BARBUR & HOOKER APARTMENTS

DAR SUBMISSION IV

DECEMBER 12, 2016

DIAMONTIS INVESTMENTS

3-STORY 'L'-SHAPED BUILDING WITH 4TH FLOOR ALONG BARBUR & PENTHOUSE ON HOOKER

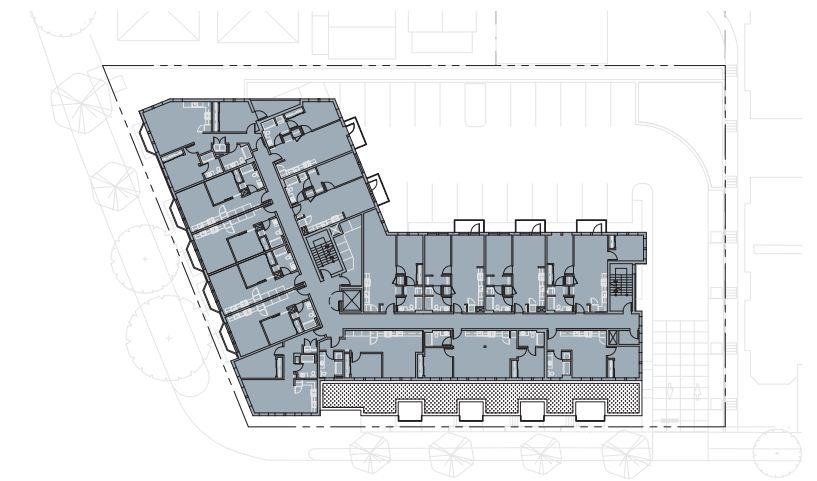
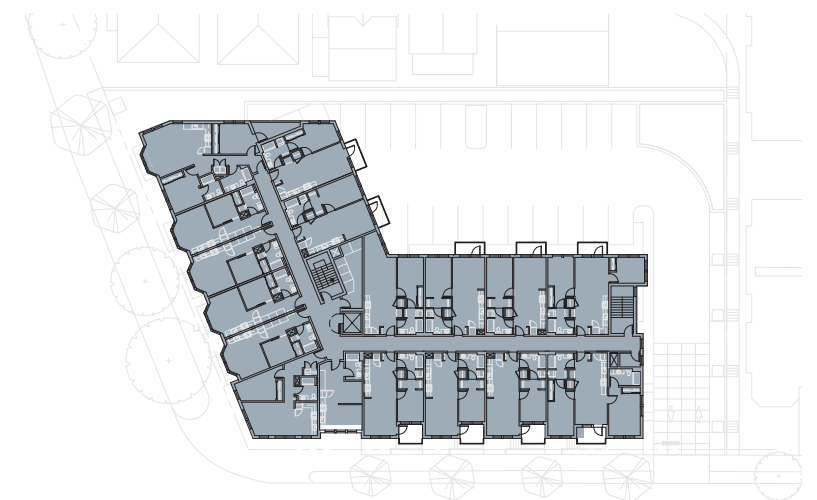
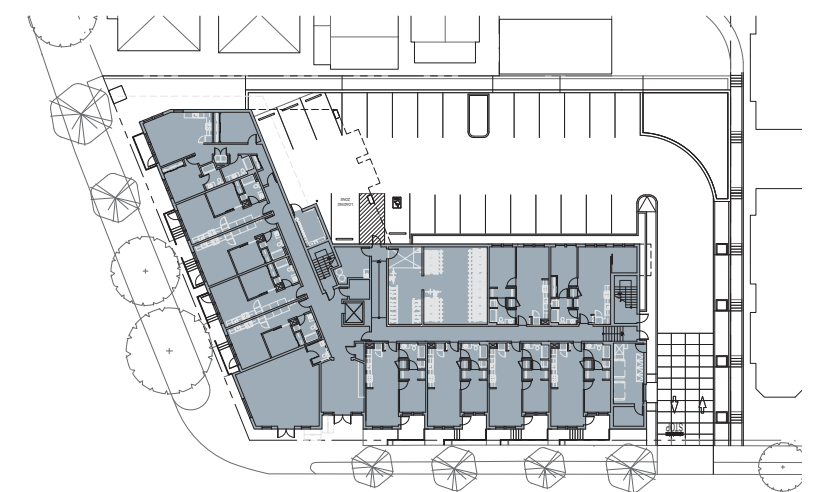
- Additional information needed to understand building height
- Building entry on SW Hooker Street vs. SW Barbur Boulevard is supported by HLC
- Fiberglass or wood windows are preferable to vinyl
- The variety of siding materials needs to be simplified
- The use of brick is appropriate for the neighborhood
- Stucco is preferable to lap siding where brick is not the primary siding material
- The architectural style needs to be more unified and harmonious

- Reduced building footprint
- Simplified siding materials - fewer and more unified
- Brick on all street facing facades
- Stepped back 4th floor everywhere except tower
- More uniform bay rhythm along SW Hooker Street
- Simplified window types - less shape variety

3-STORY 'L'-SHAPED BUILDING WITH 4-STORY TOWER & PENTHOUSE

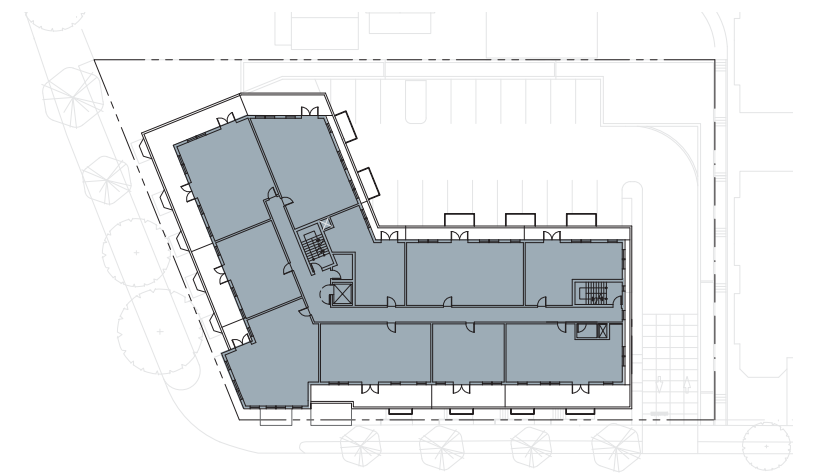
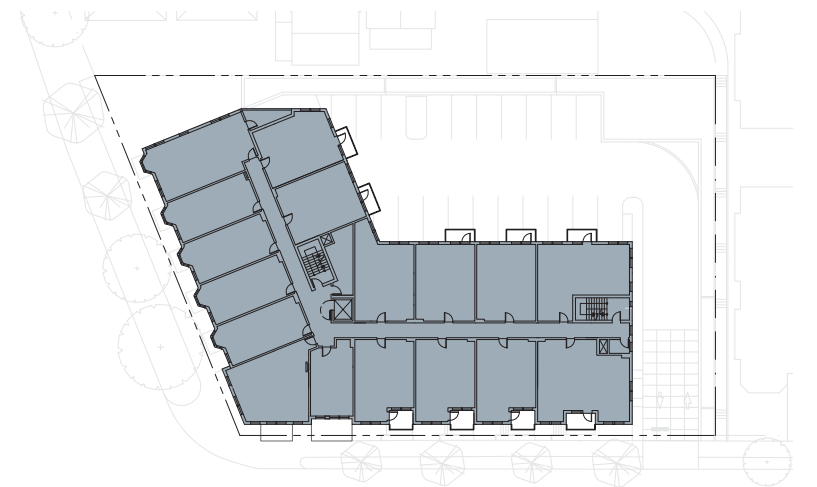
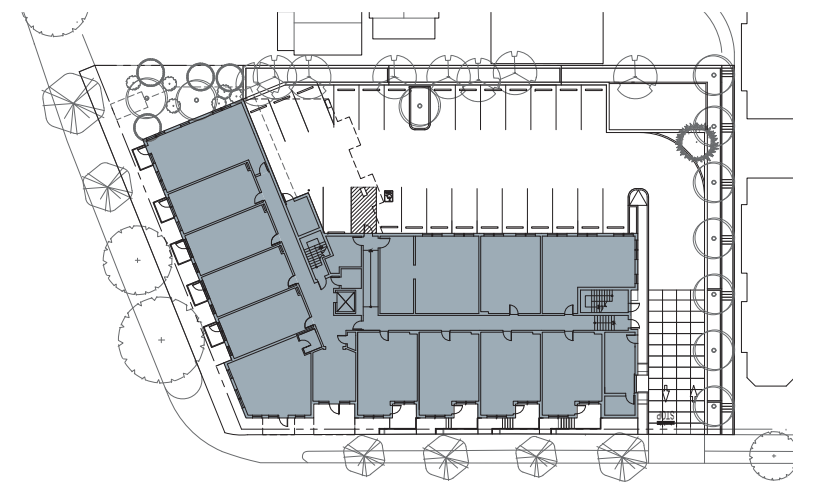
- Penthouse level needs further development regarding setbacks, rooftop equipment, detailing, and materials
- Diminish the tower to 3 stories
- Provide more refined architectural detailing at tower
- Fiberglass or wood windows are preferable to vinyl
- Windows with more mullions to break scale down are preferable to modern, undivided lights
- Stucco is preferable to lap siding for non-brick facades
- Maintain concrete datum line around base of building
- Use scored concrete at north retaining walls

- Provided underground parking
- Diminished retaining wall at North property line
- 4th floor stepped back more & on all sides to diminish its presence
- The corner retail space is removed and the building entry relocated to corner tower element
- Brick provided at interior walls of porches & balconies on SW Hooker Street
- The window types were further simplified
- Mullions were added to windows to enhance historic appearance
- Switched to Milgard Essence fiberglass windows
- Stucco panels used in lieu of fiber cement siding
- Brick cornice in lieu of wood cornice
- Brick datum line above first floor in lieu of concrete bellyband

3-STORY 'L'-SHAPED BUILDING WITH PENTHOUSE

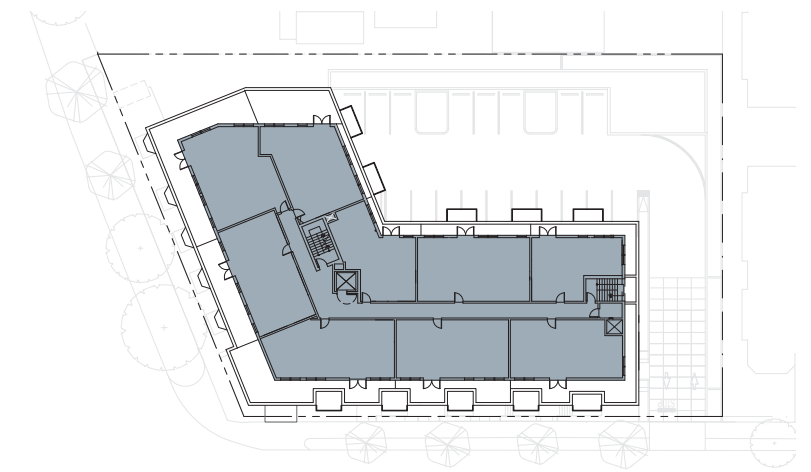
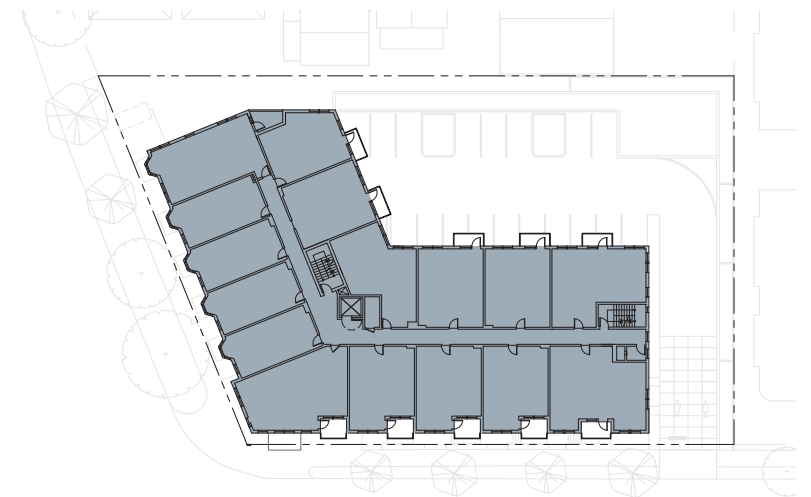
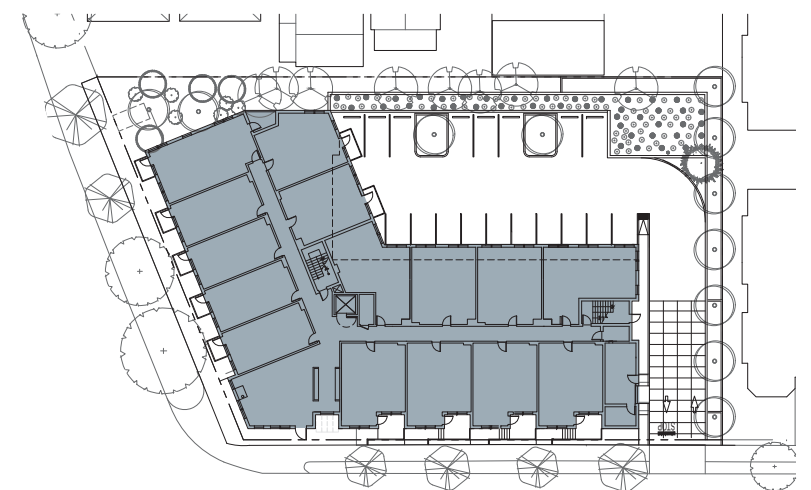
- Penthouse needs further integration into building massing
- Underground parking with sloped driveway is great because it lowers retaining wall adjacent to SW Meade Street neighbors
- 4th floor / penthouse is still too visible - it should be set back 15' on all sides or just removed completely
- Provide a deeper, brick cornice with more refined articulation at the top of the building
- Provide more significant detailing at the brickwork below the oriel bays
- Balconies need to be designed to look more intentional and permanent
- More symmetry is needed at the building entrance
- Design is much improved from previous versions

- Kept underground parking
- Kept low retaining wall at North property line
- Kept 4th floor / Penthouse
- Penthouse detailing is more refined
- More articulation at the brick cornice detailing & the brickwork at the base of the oriel bays
- More symmetry at the building entrance
- Footprint is larger & unit count increased to pay for underground parking

- 3 Story Building - 4th floor removed altogether
- Footprint is larger & unit count decreased
- No underground parking to minimize cost due to diminished unit count

- Kept low retaining wall at north end of property
- Penthouse removed
- Fully integrated 4th floor only along SW Barbur Boulevard - 3 stories along SW Hooker Street
- 4th floor designed as part of the SW Barbur Boulevard massing versus the previous "box on the roof"
- More refined and deeper articulation at the cornice detailing
- More refined brickwork at the base of the oriel bays
- More symmetry at the building entrance
- A more cohesive, unified design that references historical multi-family buildings in Portland
